11111 JEFFERSON BOULEVARD MIXED-USE PROJECT

Final Environmental Impact Report
State Clearinghouse No. 2020090329

Prepared for
City of Culver City
Culver City Case Nos:
P2021-0025- CP/DOBI/TPM/ZCMA

August 2021

Figure 2.2-1
Machado Road Median Concept

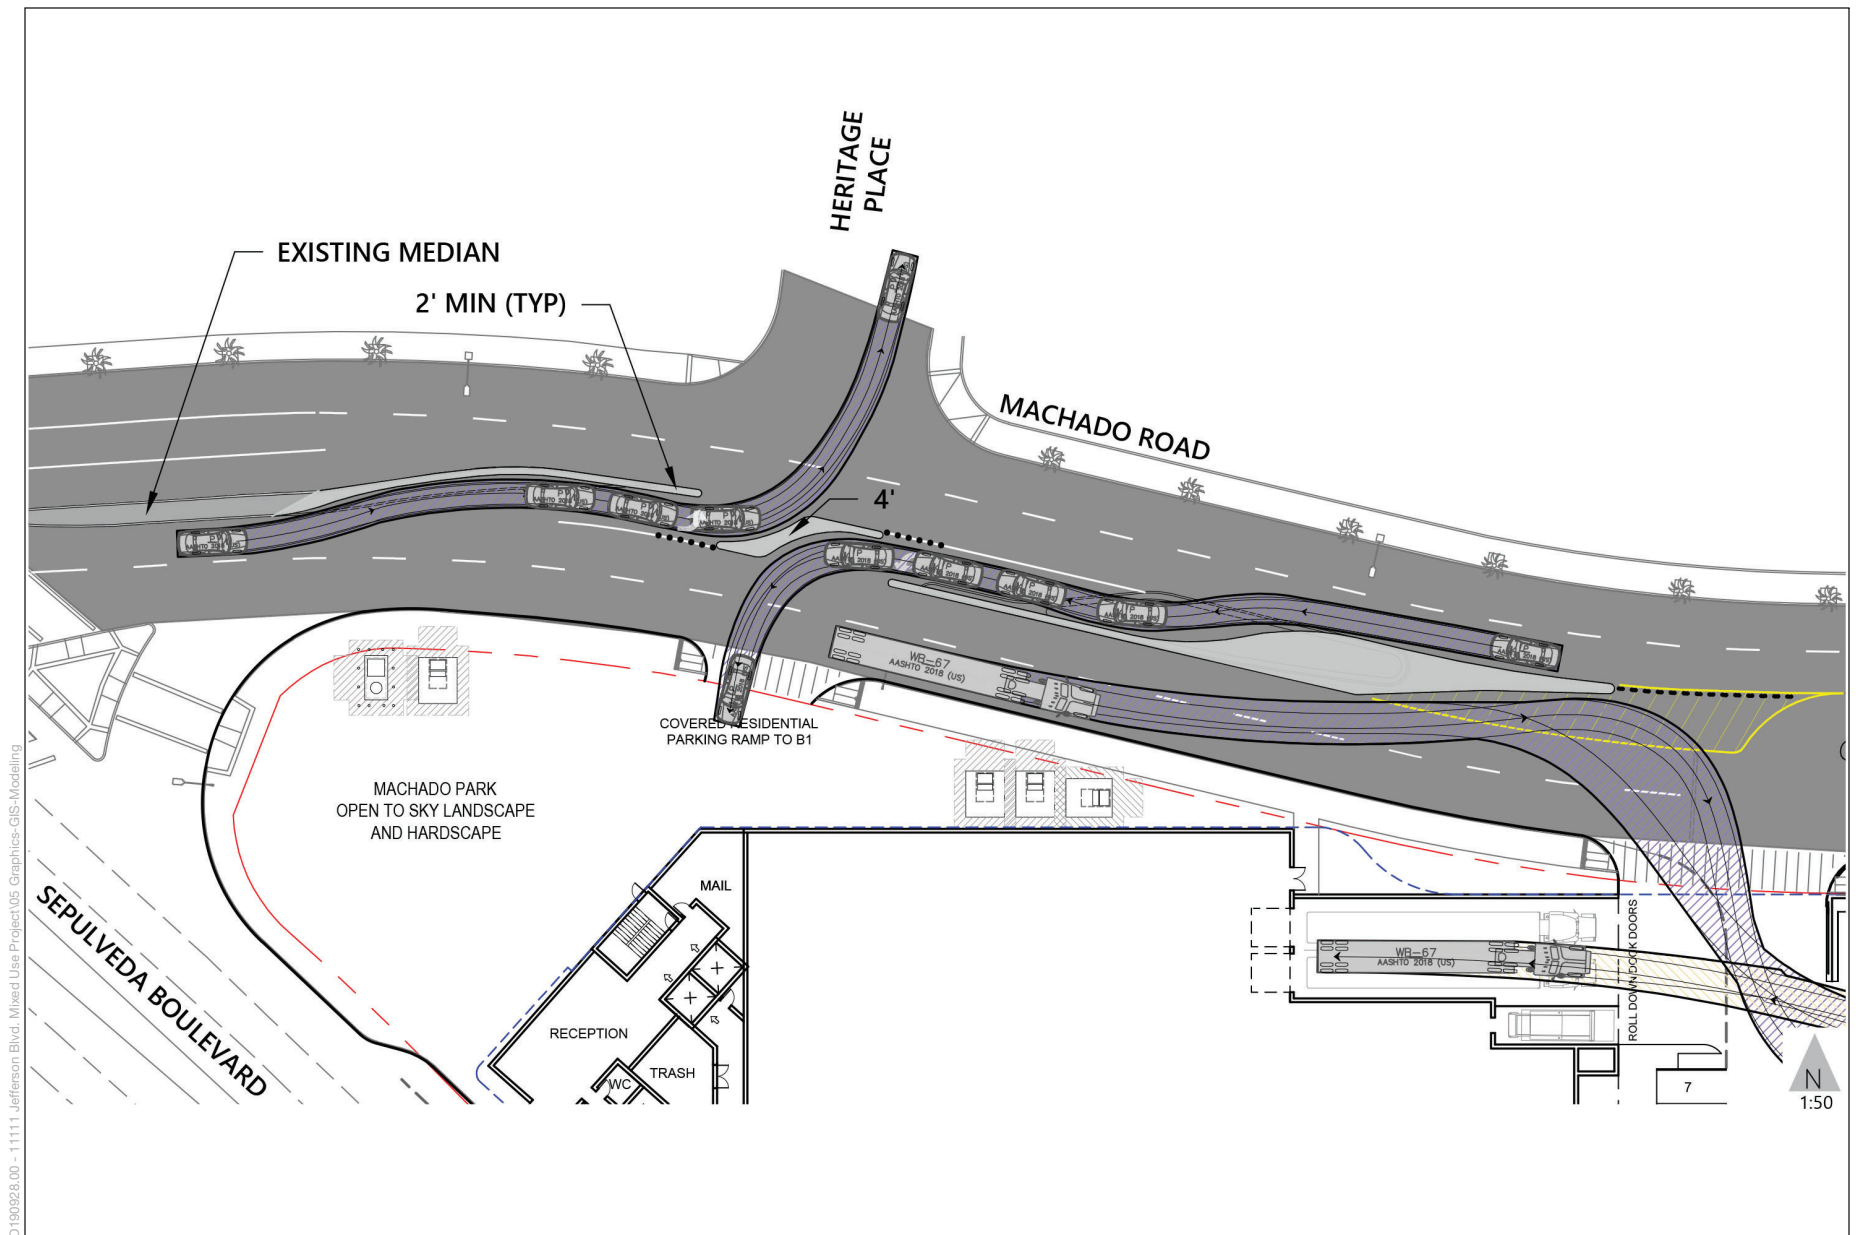
2. Design and fund an [sic] sufficient extension of the raised pedestrian sidewalk and curb at Jefferson and Ballona Lane so that there is only a right turn exit from Ballona Lane onto Jefferson, but no longer permits a right turn entry from Jefferson onto Ballona Lane (but which can still be traversed by emergency trucks). With the proposed redesign of #1 above, this will go a long way to eliminate/greatly disincentivize (a) cut through traffic into our community by vehicles wanting to avoid the Jefferson/Machado intersection and access either the Project's residential parking entrance or northbound travel on Sepulveda, and (b) parking on the private streets in our community that our HOA pay to maintain by the retail/commercial invitees of the Project or guests of the Project's residents

Cut-through traffic and parking are not considered as CEQA issues. Refer to Topical Response TR-1 regarding comments that do not relate to a threshold of significance used to assess transportation impacts of the Project under CEQA. The comment also references the safety risks and potential for collisions. Pages 4.11-21 and 4.11-22 in Section 4.11, Transportation, of the Draft EIR, discuss the safety of the driveways. As discussed therein, the Project would not substantially increase hazards or conflicts due to a geometric design feature under Threshold TRAF-3. All Project driveways as originally proposed would be designed to comply with City standards, provide adequate sight distance, and protect safety for all roadway users. Therefore, impacts were found to be less than significant.

Nevertheless, in response to the concerns raised in the letter, these comments were discussed with City staff and Richard Ochoa, representative of The Classics at Heritage Park Homeowners Association (HOA), during a meeting held and recorded at 4:00 P.M. on June 16, 2021. As a result of this meeting, it was agreed that the Project would construct a raised median on Machado Road in a manner to preserve left-turn access from eastbound Machado Road into the Heritage Park neighborhood and provide left-turn access from westbound Machado Road into the Project Site for residents, while physically separating the opposing left-turn pockets and physically prohibiting through and left-turning movements from either Heritage Place or the Project's residential driveway at Machado Road. **Figure 2.2-1, Machado Road Median Concept**, illustrates the concept for this median island. Vehicles exiting the Project residential driveway would be required to turn right onto eastbound Machado Road. Other measures such as signage and vertical delineation would also be introduced along Machado Road to reinforce turn prohibitions, including U-turn prohibitions on Machado Road. The Project would also install a raised curb extension at the intersection of Ballona Lane and Jefferson Boulevard that would prohibit any entry except for emergency vehicles into the Heritage Park neighborhood from Jefferson Boulevard, and only allow for eastbound right-turns from Ballona Lane out of the neighborhood. **Figure 2.2-2, Ballona Lane Access Restriction Concept**, illustrates the concept for this closure. The exact dimensions and design of these features at the entrances to the Heritage Place community would be determined

during the preparation of construction plans and will be approved by the City. These changes and refinements to access provisions are now reflected in Chapter 2, Project Description, of the Draft EIR, as shown in Section 3, Revisions, Clarifications, and Corrections to the Draft EIR, of this Final EIR. These changes do not alter the impact findings in the Draft EIR or result in any new or substantially more severe significant impacts, as the revised Project driveways would also be designed to comply with City standards, provide adequate sight distance, and protect safety for all roadway users.
